Re: Indian Point, Unit No.1  
Docket No. 50-003  
NL-08-035

Subject: **Reply to Request for Additional Information (RAI) Regarding Indian Point 1 License Amendment Request (LAR) for Fuel Handling Building Crane**

Attachment 1: Additional Information for IPEC Unit 1 Fuel Handling Building crane License Amendment Request .

Attachment 2: Second RAI Figures and Tables for RAI IPEC Unit 1 Fuel Handling Building Crane License Amendment Request

FIGURE 1

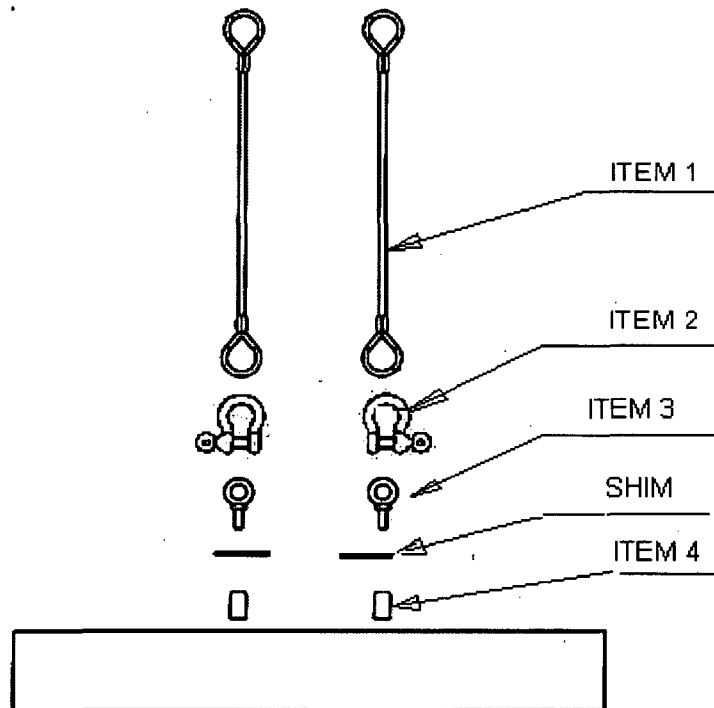
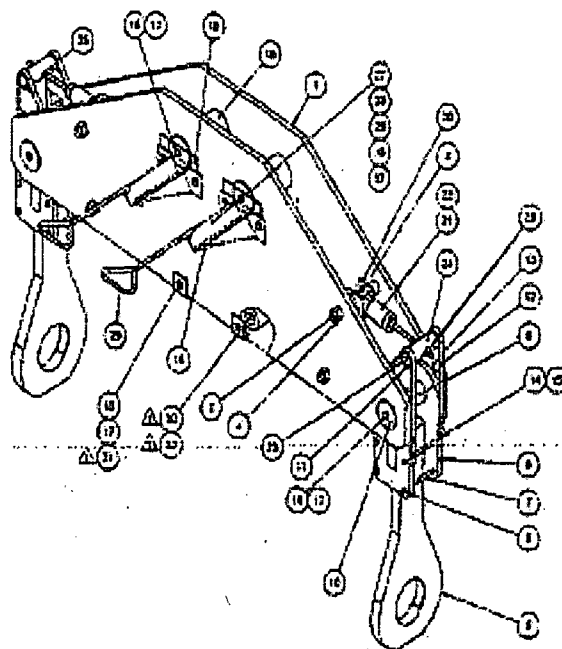
**2. Provide an analysis and evaluation of consequences for the MPC lid drop onto the Transfer Cask flange that conforms to the guidance of NUREG-0612, Appendix A.**

The analysis in Section 4.7.2(e) assumes the lid falls in a perfectly horizontal orientation through the water. This orientation maximizes the drag forces on the lid, which in turn minimizes the impact velocity on the cask flange, and therefore minimizes the consequences of lid impact on the fuel basket. On-the-other-hand, if the lid falls in a side first orientation, the drag forces are considerably less, the impact velocity significantly higher and the consequences more severe.

Finally, the weight of the lid, with a drain tube, is about 10,000 lbs. Each of the four wire rope slings was tested to 14,140 lbs. The shackles, eyebolts, and bushings were rated or analyzed to a minimum 7070 lbs vertical load and the tested loads are higher. This is a four point lift on the lid and a two point lift on the Lift Yoke sling pins. (Two of the four slings are attached to each of the 1.5" diameter Yoke Sling Pins. Refer to attached sketch of Lift Yoke.)

The table which follows shows the actual safety factors against the failure of rigging. Each of the sling pins has a rated load of 50,000 lbs and has been certified to NDE standards, providing a safety factor of 10. The crane hook, cable, etc. have been subject to a 125% load test based on the 75-ton rating. Therefore, while carrying the MPC lid, the crane safety factor is well in excess of 10 against a structural failure.
